## REVISED RESPONSE TO REQUEST FOR ADDITIONAL INFORMATION

### APR1400 Design Certification

Docket No. 52-046

**RAI No.:** 226-8235  
**SRP Section:** 03.07.02 – Seismic System Analysis  
**Application Section:** 3.7.2  
**Date of RAI Issue:** 09/25/2015

Figure 1 The FE model for RCS in SSI and structural analyses

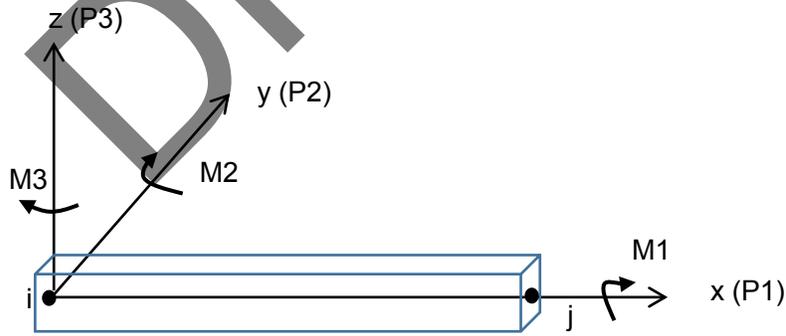
To assist the staff in evaluating whether the aforementioned masses and their effect have been adequately considered in the seismic analysis and design, the staff requests the applicant to clarify if these masses are included in or excluded from the FEMs used in the SSI analyses. If the hydrodynamic masses were included in the FEMs used in the SSI analyses, describe the process used to estimate the slosh height. If the masses described in the paragraph above are excluded from the FEMs used in the SSI analyses, describe the process (including a numerical example) for developing design loads that correspond to these masses and how these loads are combined with the seismic design loads. Additionally and as necessary, correct any inconsistencies between the aforementioned technical reports.

The RCS FE model (same as in SSI model) is included in the structural analysis model for the internal structure in order to consider the effect of RCS mass, as shown in Figure 1. It is made up of beam elements (BEAM4 in ANSYS) and mass elements. To connect the RCS model and internal structure, the rigid beams shown in yellow in Figure 1 are used. Table 1 summarizes the comparison of member end forces from the SSI analysis to those from the structural analysis at the major RCS frame supports.

Since the results of member end forces in the structural analysis are greater than those in the SSI analysis, the RCS masses are adequately considered in the structural design.
